Subject: SES Solar Two (08-AFC-5)
Responses to CEC and BLM Data Requests 128-141
URS Project No. 27657106.00608

**In Response to CEC & BLM Data Requests 128-141
Set 2, Part 1
Application for Certification (08-AFC-5)
SES Solar Two, LLC**

SES Solar Two
In Response to CEC and BLM Data Requests
Set 2, Part 1
Data Requests 128-141
08-AFC-5

CREATED BY: LG	DATE: 05-22-09	FIG. NO:
PM: WM	PROJ. NO: 27657106.00608	132-1

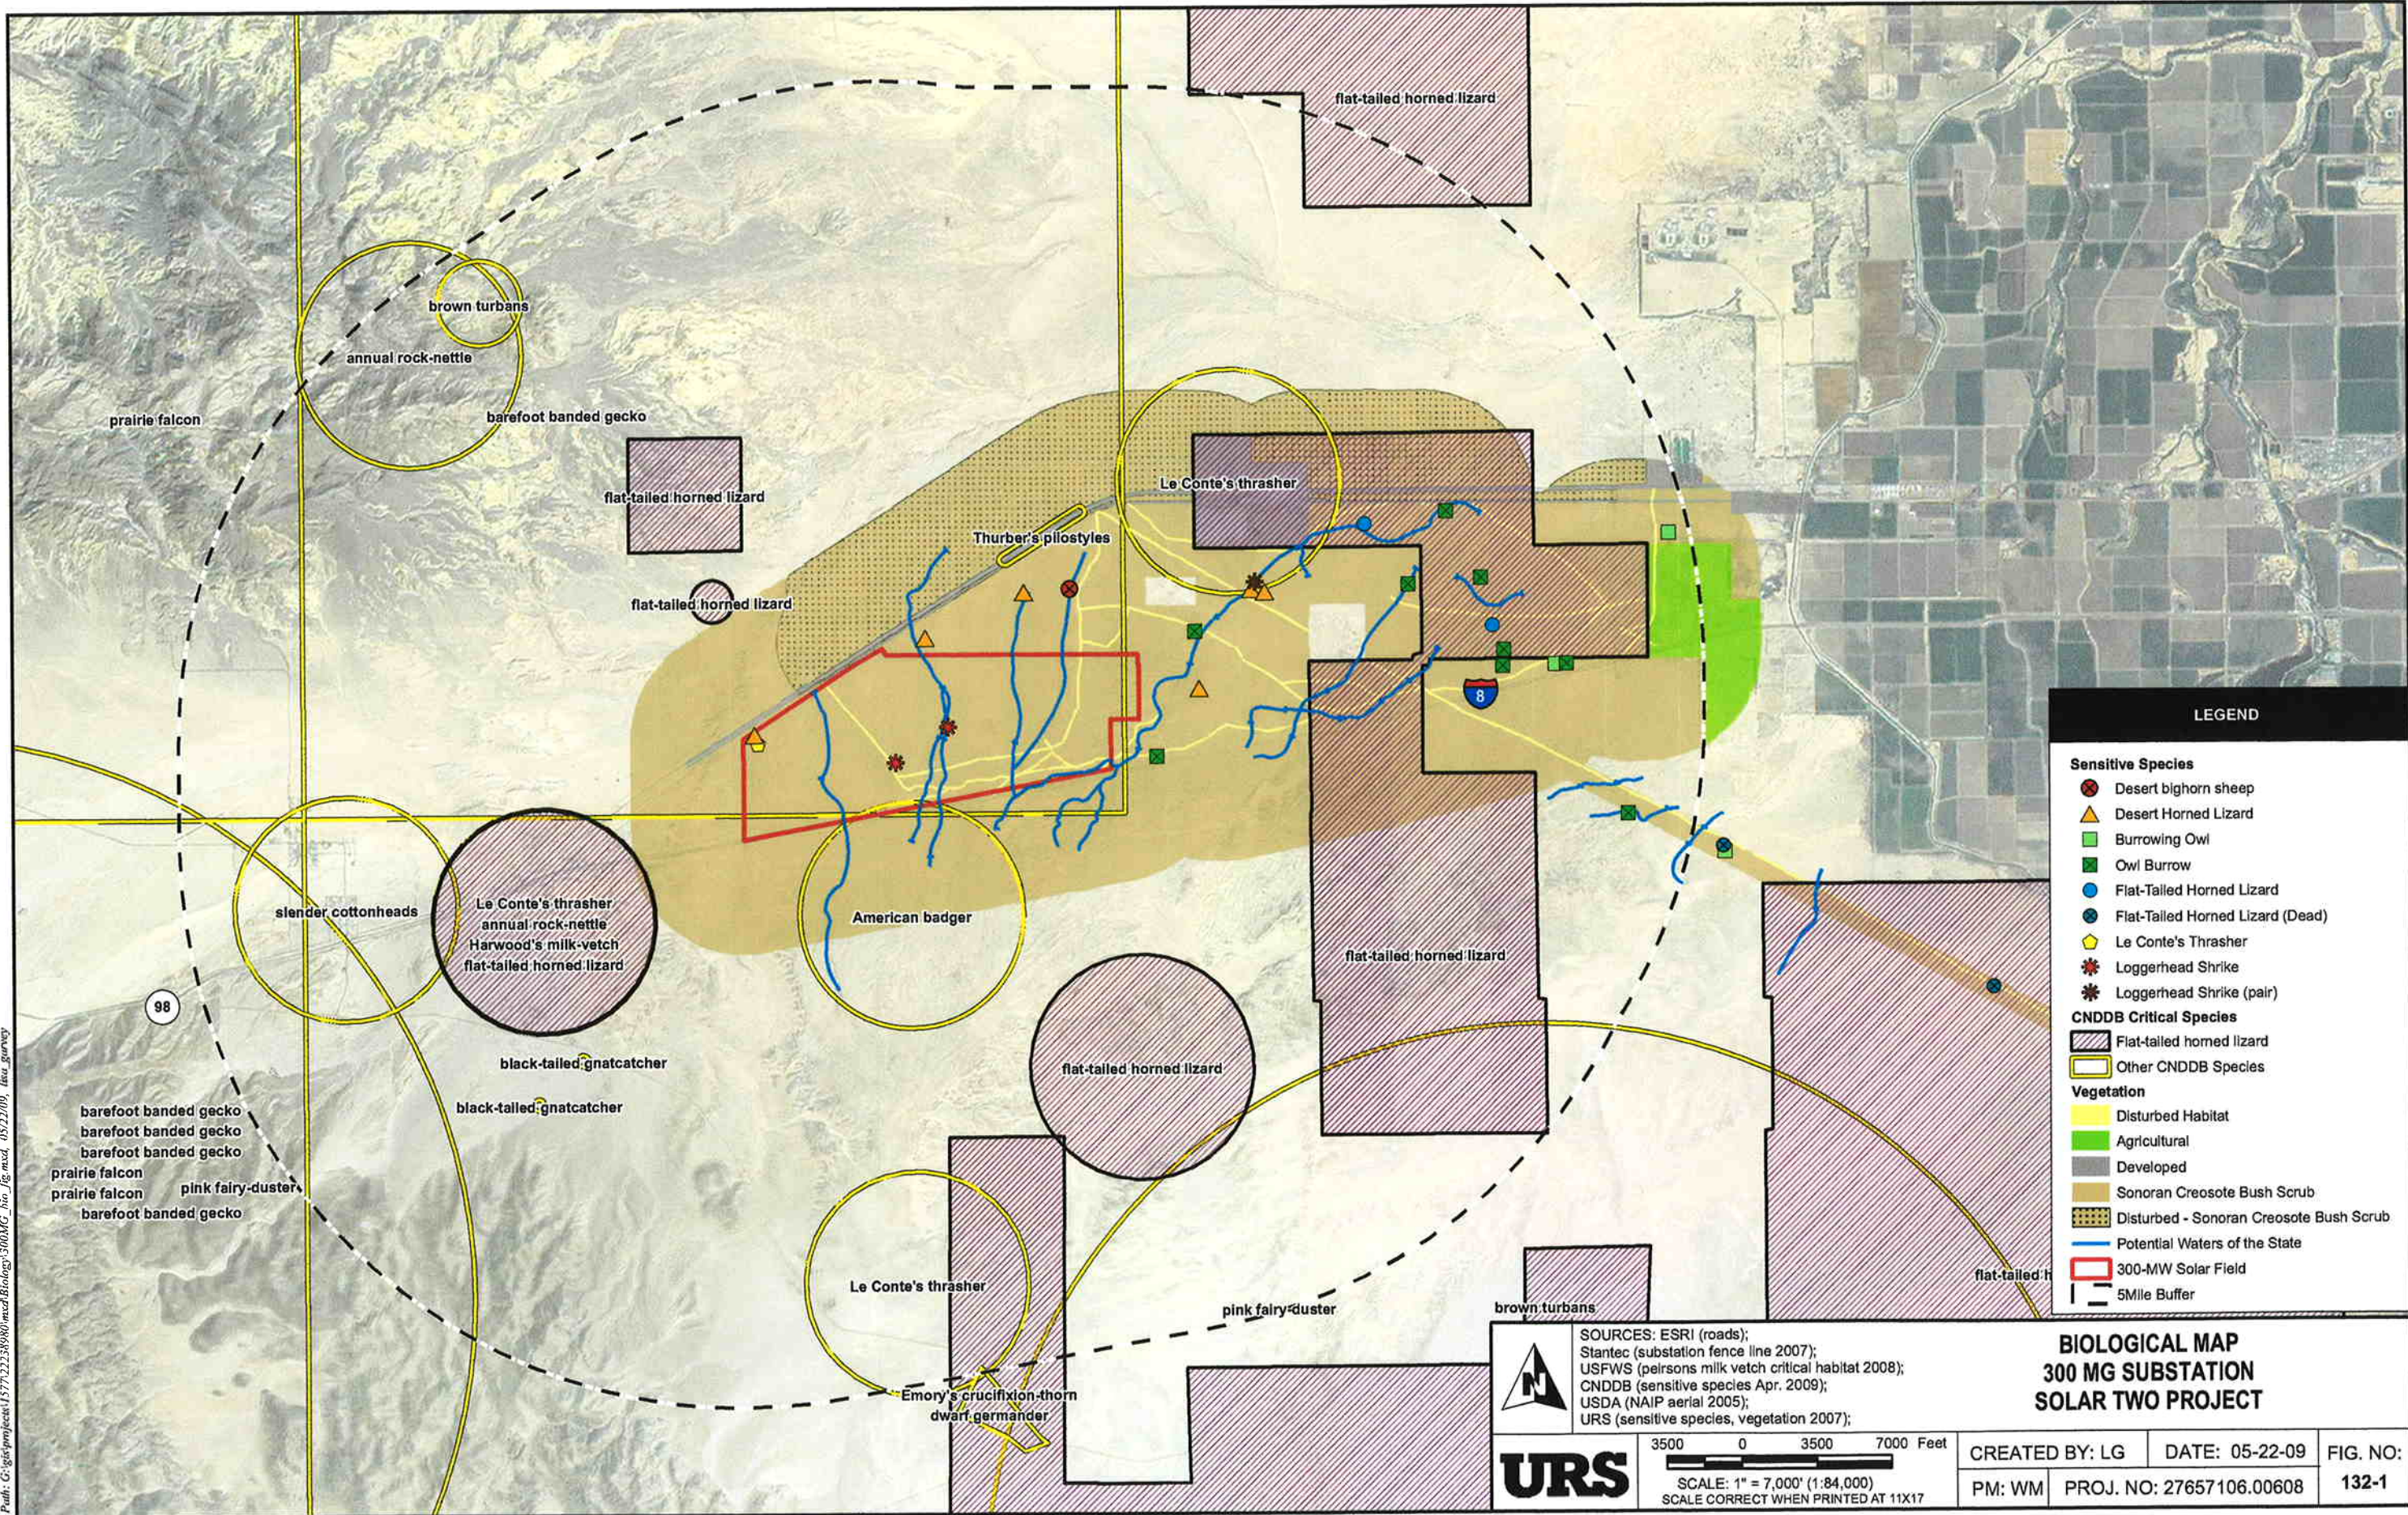
Data Request 132: In order to facilitate preparation of the PSA/DEIS document and allow further analysis of this alternative, please provide the Biology and Cultural survey results for the 300 MW Alternative (Phase 1) separate from those of the complete Proposed Project.

Figure 132-1, attached behind this response as BIO-1 shows documented biological resources within and adjacent to the 300MW alternative. The table below summarizes the vegetation acreages for the 300MW site.

Sensitive species occurrences within the 300MW site include flat-tailed horned lizard (*Phrynosoma mcallii*; one sighting location), Le Conte's Thrasher (*Toxostoma lecontei*; one location), and loggerhead shrike (*Lanius ludovicianus*; two locations). Bighorn sheep (*Ovis canadensis nelsoni*; BHS), an endangered species, were detected in March 2009. The BHS sighting location occurs north of the 300MW alternative site (see attachment BIO-1). Additional flat-tailed horned lizard sighting locations and potential burrowing owl burrows occur in areas adjacent to the north and east boundaries of this alternative.

Five flood flow channels that are potential waters of the state are also associated with this site (see attachment BIO-1).

CREATED BY: LG	DATE: 06-02-09	FIG. NO:
PM: AL	PROJ. NO: 27657106.00608	134-3

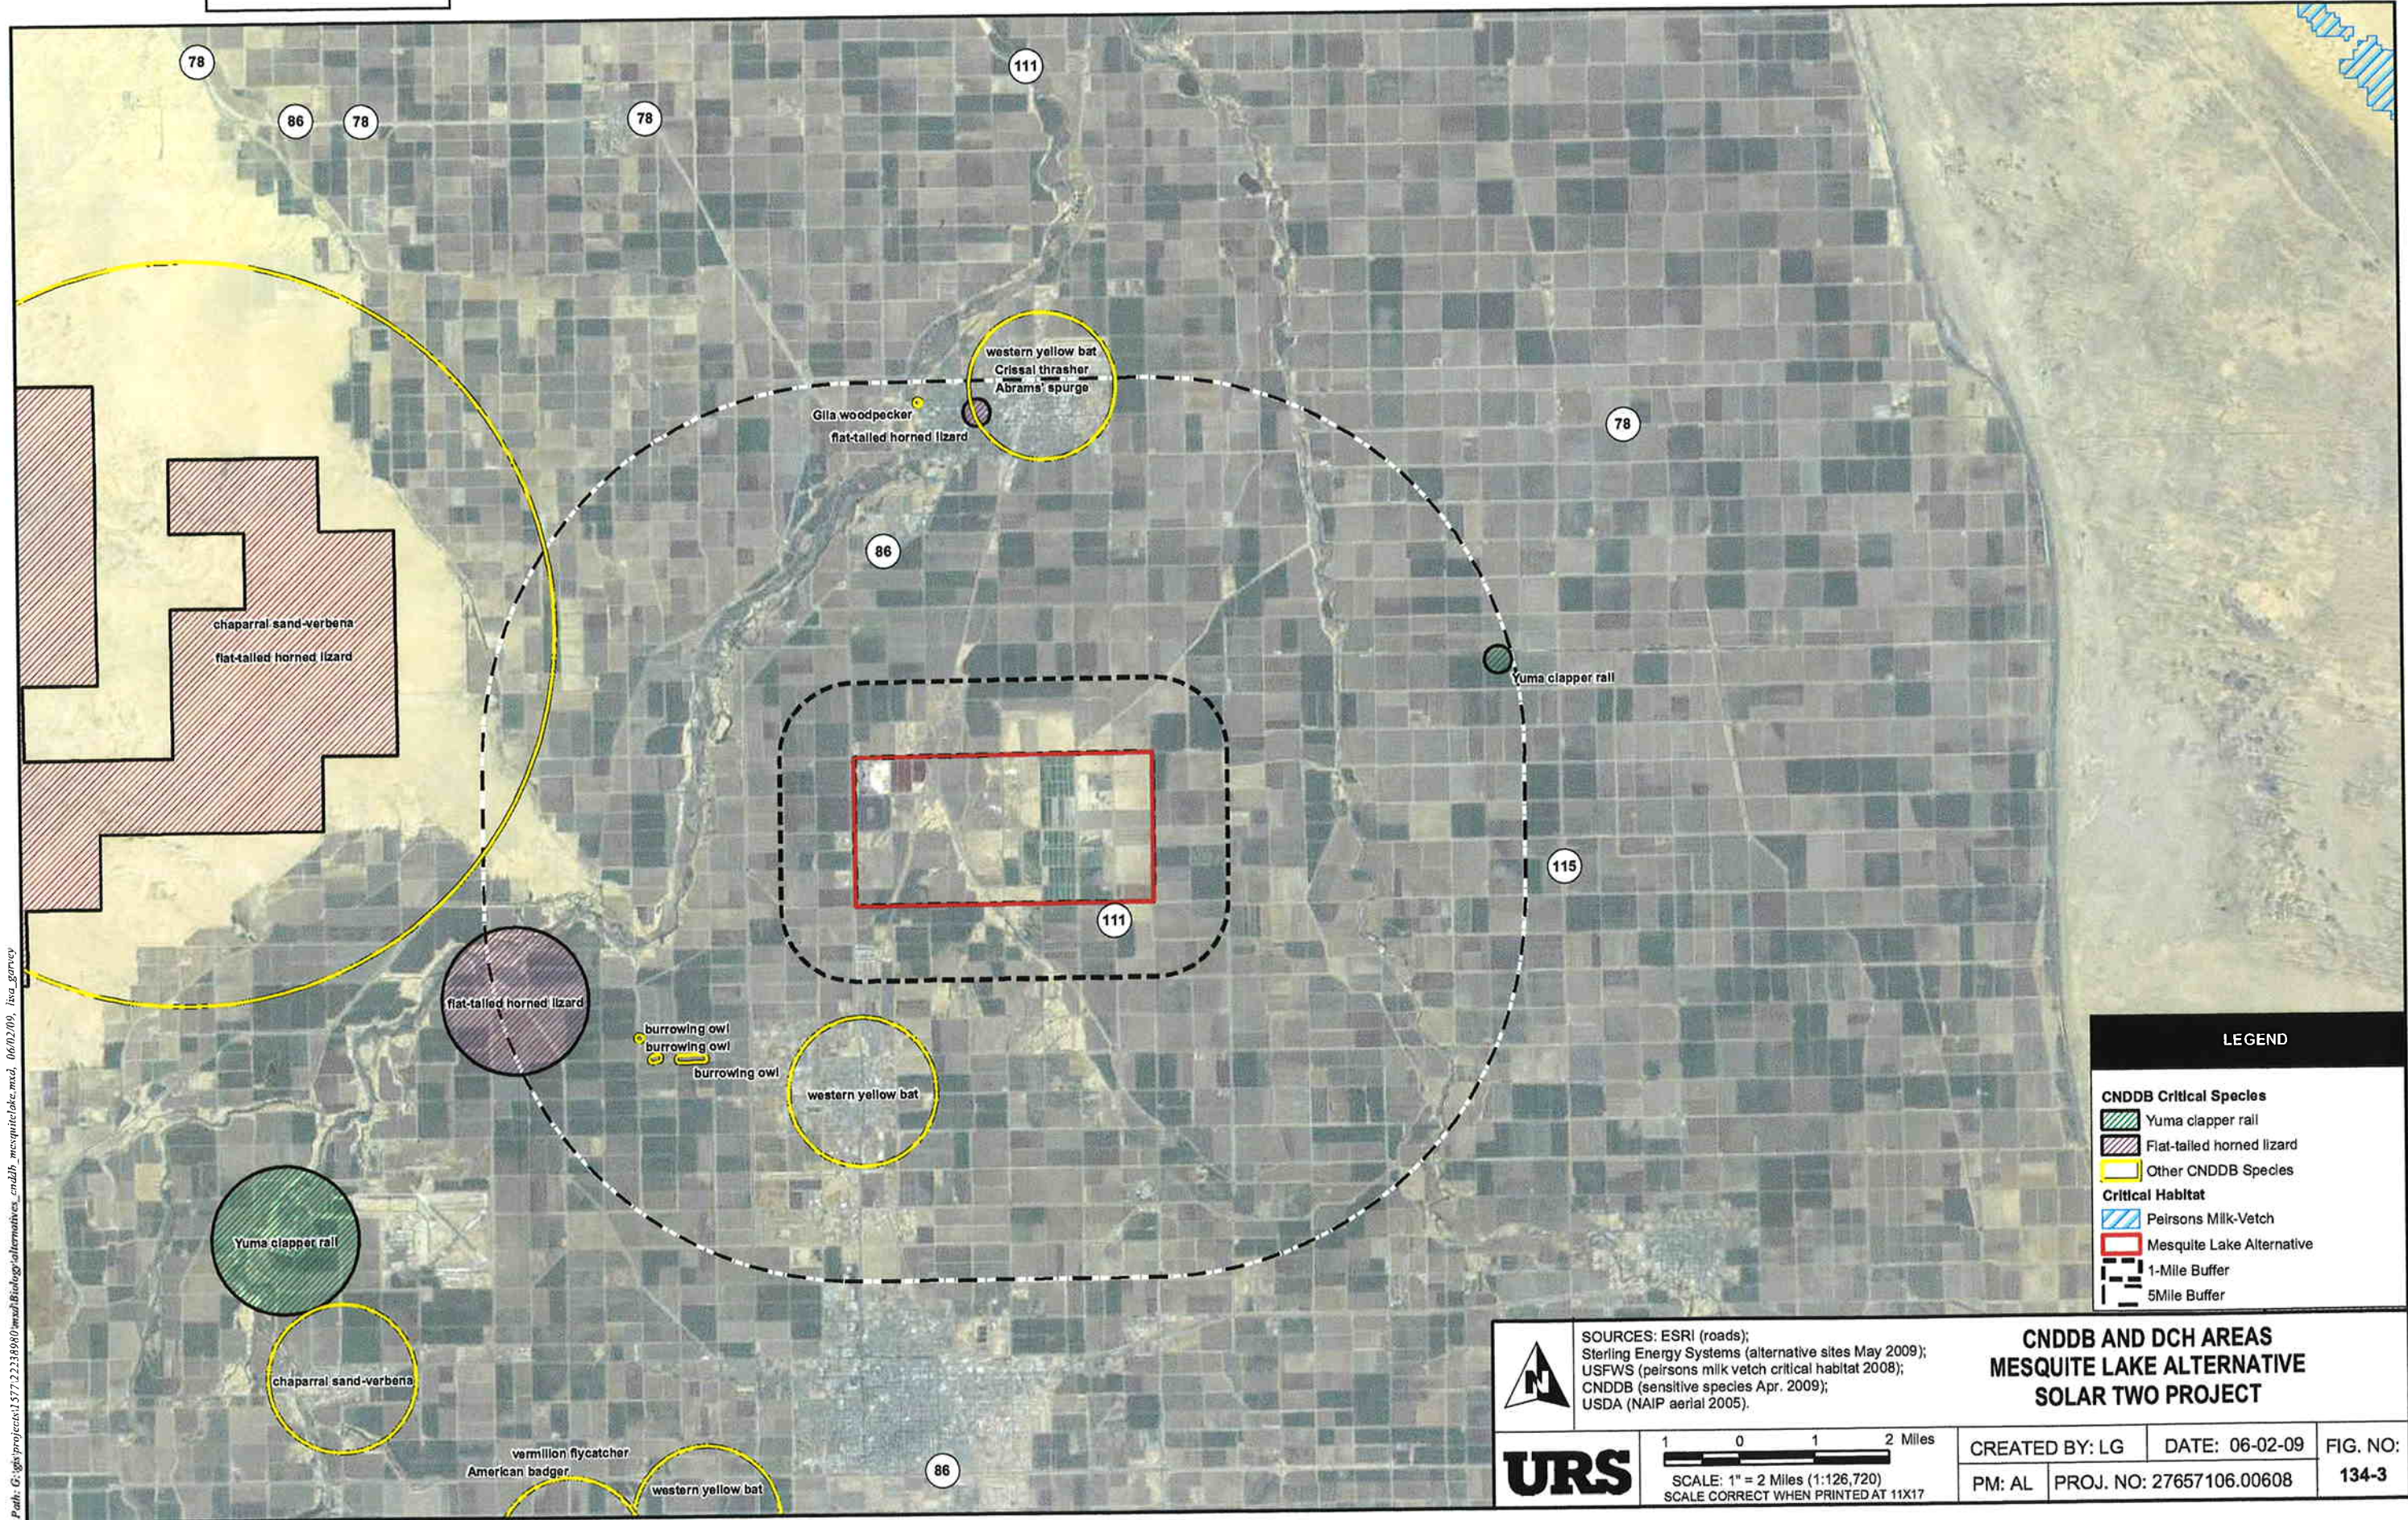
- **Biological Resources:** One of the site selection criteria for the proposed SES Solar Two site was to avoid highly pristine or biologically sensitive areas. In order to assess this criterion for the alternative sites, please provide the results of the CNDDDB search for the South of Hwy SR 98 site, the Mesquite Lake Alternative, and the Border Lands Alternative.
- **Cultural Resources:** Due to the extensive cultural resources present at the proposed SES Solar Two site, alternative sites are being sought that may impact fewer cultural sites while still achieving the required site criteria. Please provide an Information Center search (Class I) for recorded sites identified within the potential South of Hwy SR 98 site, the Mesquite Lake Alternative, and the Border Lands Alternative.

Figures showing the results of the CNDDDB query are attached. Also attached are the GAP Analysis vegetation maps for each alternative site.

The primary land cover of this alternative site is active and inactive agricultural lands, with some apparent desert scrub and arid riparian habitats. No sensitive species sightings occur within the immediate vicinity. Burrowing owl is likely to be present. A major drainage passes through the site. Please see Figures 134-3 and 134-4, provided behind this response as attachments BIO-4 and BIO-5, respectively.
